Access Compliance Report

Public Rights-of-Way

(Curb Ramps)

| Intersection ID: 6363 | Main Street: IREDELL_DR | Cross Street: MILHAVEN_LN | Location: NW |

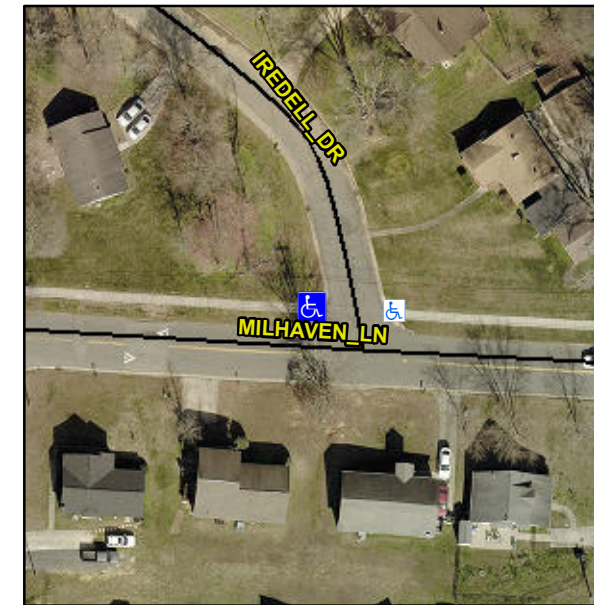
| ADA ID: 0BD601B1315E | Ramp Type: BlendTrans1 | Initial Pass/Fail: Fail | Overall Compliance: No |

Not Found, R304.5.3

| Compliance | Description | Data | Compliance | Description | Data |
|------------|-----------------------|------|------------|-----------------------------|------|
| Yes | Ramp Width (in) | 60.0 | No | BlendTrans XSlope (%) | 3.1 |
| | | | No | Curb Slope (%) | 9.4 |

Remove & Replace Curb Ramp With Two New Directional Ramps or Equivalent.
